TOLERANCES (UNLESS OTHERWISE NOTED)	WESTERBEKE CORPORATION AVON MA. 02322		
INCHES / MILLIMETERS .XX ±.02 / X. ±; .XXX ±.005 / .X ±; CAST ±.03 / .XX ±; ANGLES ±.5°; FINISH 63	TITLE WIRING DIAGRAM, 20.0 KW.BEG AND 25.0 BEG GASOLINE GENSETS		
	DRAWN BY WRM	DATE 18 AUG 94	MATERIAL: -
DIMENSIONS INCHES / MILLIMETERS (WHEN APPLICABLE)	APPROVED BY	DATE	
	SCALE -	SIZE E	DRAWING NUMBER 40620
	SHT. 1 OF 1		REV. C

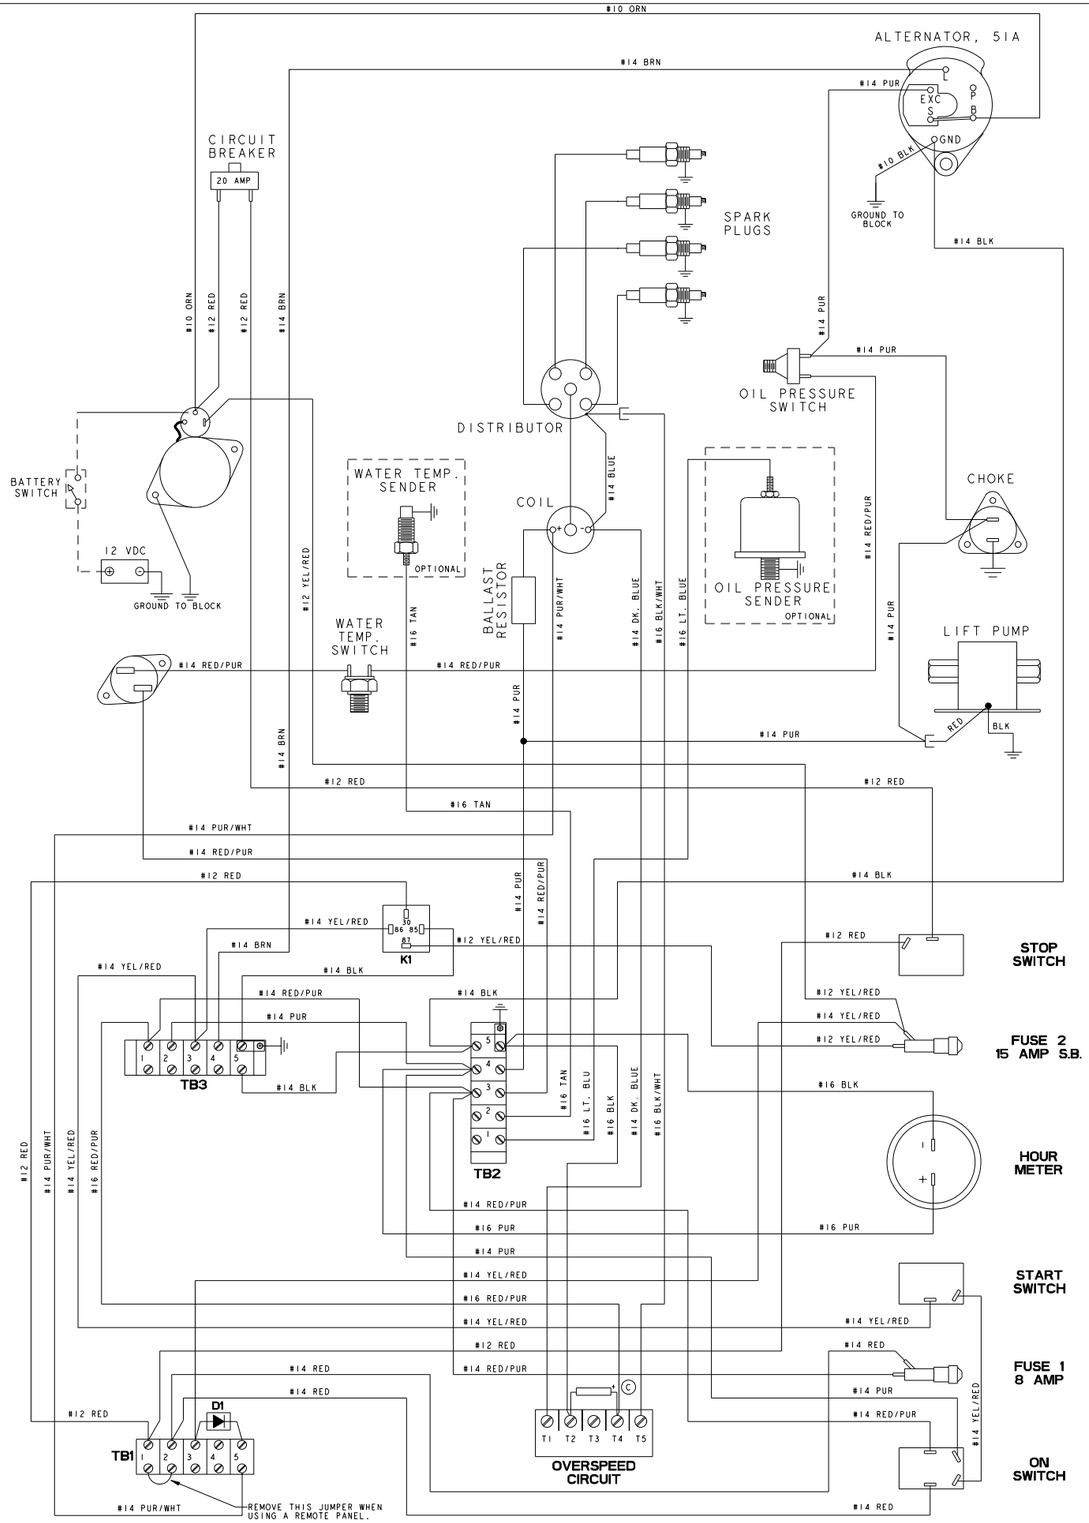
ECO NO.	DATE	REV.	REVISION RECORD	AUTH.	DR.BY
2686	3-1 95	A	ADDED NEW OVERSPEED SWITCH AND UPDATED DIAGRAM AND SCHEMATIC. ADDED OLD OVERSPEED DETAIL		WRM
2729	4-19 95	B	CHNG'D #16 RED/PUR FROM OS-T47TB3-2 TO OS-T47TB3-1 UPDATED BOTH SCHEMATIC AND DIAGRAM		MKM
3925	12/18 98	C	ADDED CAPACITOR TO SUPPRESS STARTER NOISE		MMM
